FE Civil Practice Exam

Errata posted 7/1/2022

Question 68, p. 42:

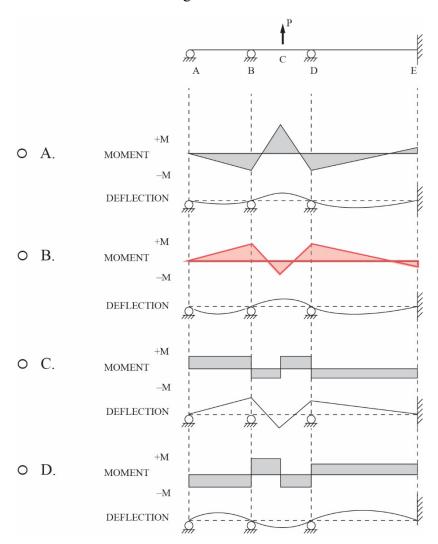
Option B should be drawn as follows:

Which combination of moment diagram and deflection shape most accurately corresponds to the continuous beam with loading shown?

Solution 67, p. 91

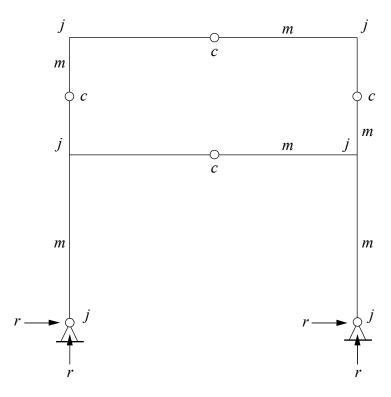
An alternate solution for this question is as follows:

Refer to the Stability, Determinacy, and Classification of Structures section in the Civil Engineering chapter of the FE Reference Handbook.

For a plane frame:

m = number of members = 6 (4 columns, two beams)

r = number of independent reaction components = 4 (x and y reactions at base of both columns)

j = number of joints = 6 (base of each column, each beam-column connection)

c = number of condition equations based on known internal moments or forces = 4 (each internal pin)

$$3(m) + r = 3(j) + c$$

3(6) + 4 = 3(6) + 4 so frame is stable and statically determinate.

THE CORRECT ANSWER IS: B
